Model: 3000-sheet Finisher for NAD 30S/30/40		Date: 30-Jun-98	No: 1
Modified Article: Front Positioning Fence, etc.		Prepared by: S.Tomoe	
From: QAC Field Information Dept.			
Reason for Modification:	<input type="checkbox"/> Parts catalog correction <input type="checkbox"/> Vendor change <input type="checkbox"/> To meet standards <input type="checkbox"/> To facilitate assembly <input type="checkbox"/> To improve reliability () <input type="checkbox"/> Part standardization <input checked="" type="checkbox"/> Other

To prevent the positioning fence in the staple tray from coming out of position, the following parts have been changed.

Model: 3000-sheet Finisher for NAD 30S/30/40	Date: 30-Jun-98	No: 1
--	-----------------	-------

Fig. 1

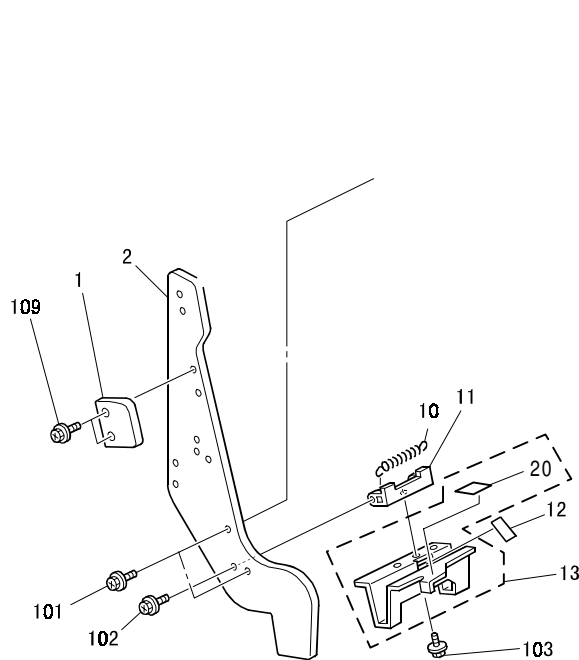
Note 1: Refer to Fig. 1.

Old part number	New part number	Description	Qty	Int	Page	Index	Note
A6974210	A6974211	Front Positioning Fence	1	X/O	15	13	1
A6974205	A6974207	Rear Positioning Fence	1	X/O	15	14	
	A6974213	Decal – Front Positioning Fence	1		15	20	1
	A6974149	Decal – Staple Unit Holder	1		17	41	2

Fig. 2

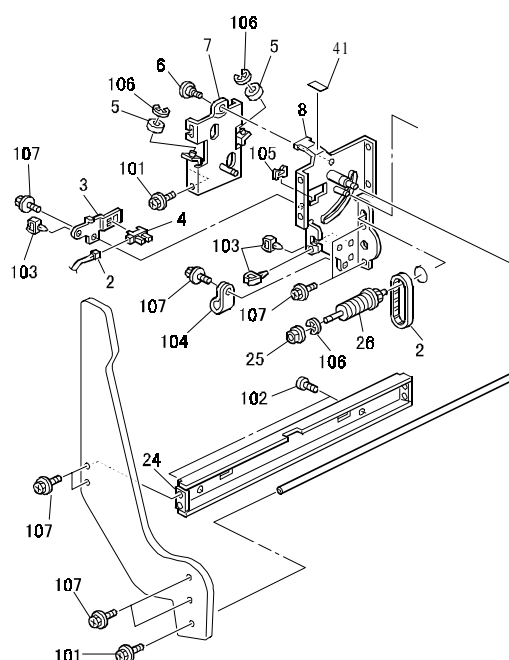
Note 2: Refer to Fig. 2.

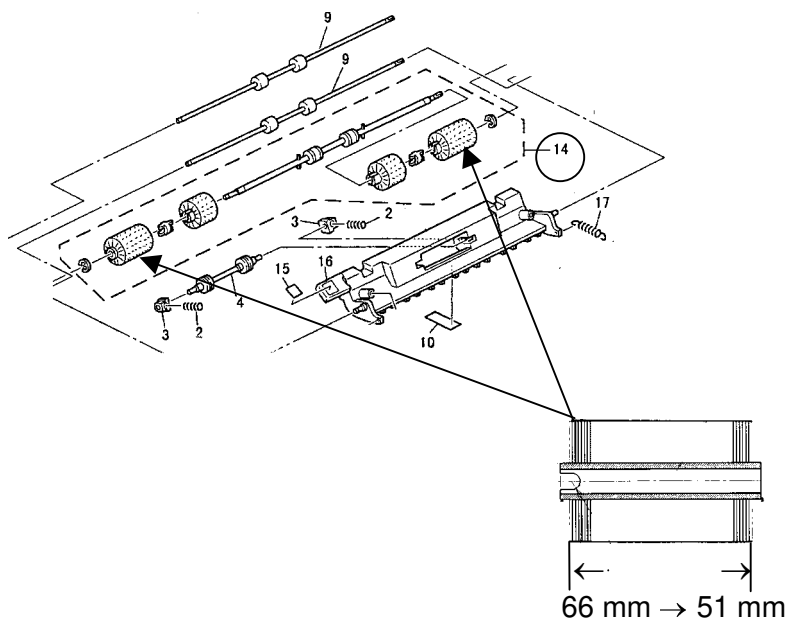
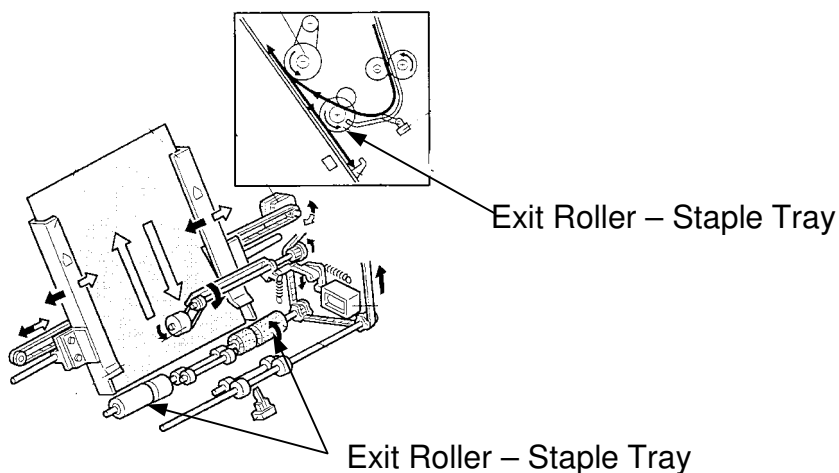
To prevent non-stapling when there are stacking problems with face-curved output, the width of the outer rollers has been changed from 66 mm to 51 mm.

Stacking problems occur with curled copies, because the trailing edge of the copy gets stuck on the brush rollers instead of being stacked properly.

Old part number	New part number	Description	Qty	Int	Page	Index	Note
A697-2135	A697-2146	Exit Roller – Staple Tray	2-2	X/O	11	14

Paper Curl Kit: A697-9512

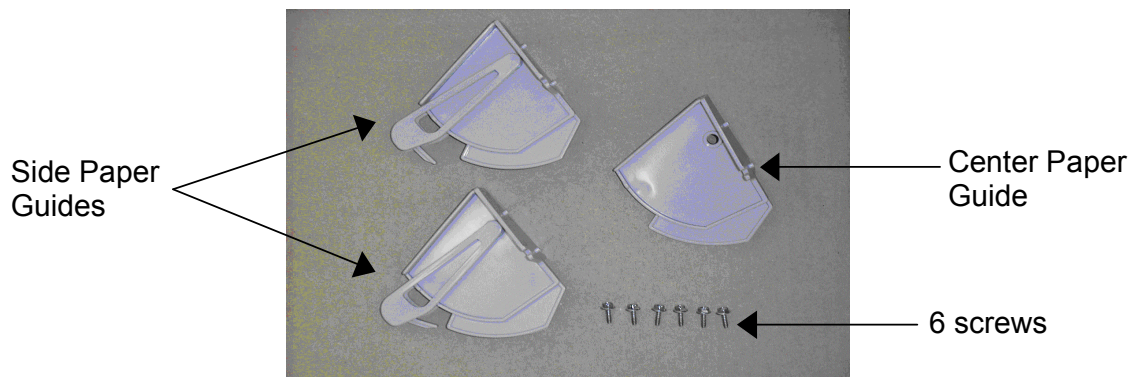
The paper curl kit P/N: **A697-9512** has been registered as a service part. The screw holes for the curl kit have been added to the left upper cover. The part number of the cover has been changed.

Note: This paper curl kit is only for the SR730 installed on the NAD.

Do not use this kit for the SR730 installed on the SP5.

Old part number	New part number	Description	Qty	Int	Page	Index	Note
-	A697-9512	Paper Curl Kit	1	-	-	-	-
A697-6181	A697-6182	Left Upper Cover	1-1	X/O	7	9	-

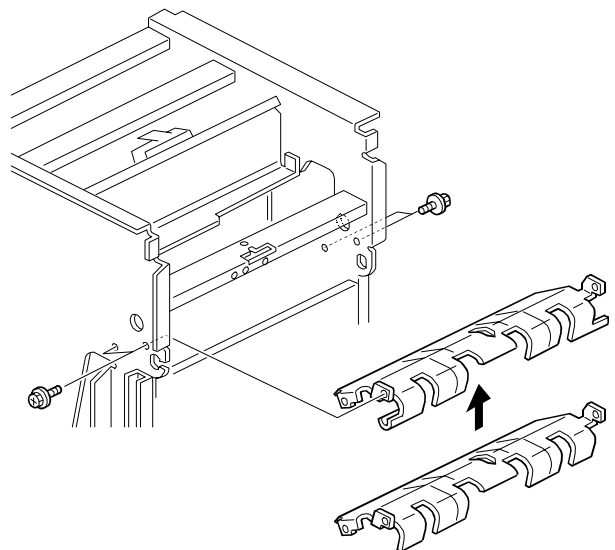
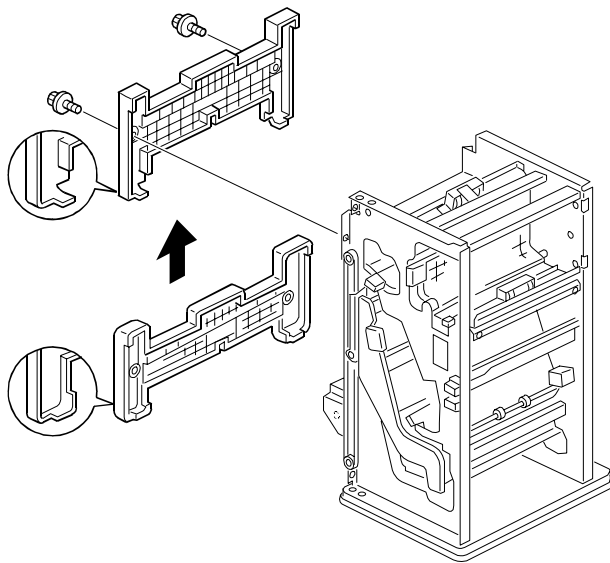
As the fed-out paper is being stacked in the Shift Tray, the trailing edge rubs past the edge of the Left Upper Cover, causing the stack to become disordered. To prevent this, a small section of the vertical plate attached to the inside of the cover has been cut out. In addition, a small, rounded section has been added to the edge of the Lower Exit Guide to improve stacking.

Old part number	New part number	Description	Q'ty	Int	Page	Index	Note
<i>A6976182</i>	A6976183	Left Upper Cover	1-1	X/O	7	9	
A6972180	A6972181	Lower Exit Guide	1-1	X/O	25	17
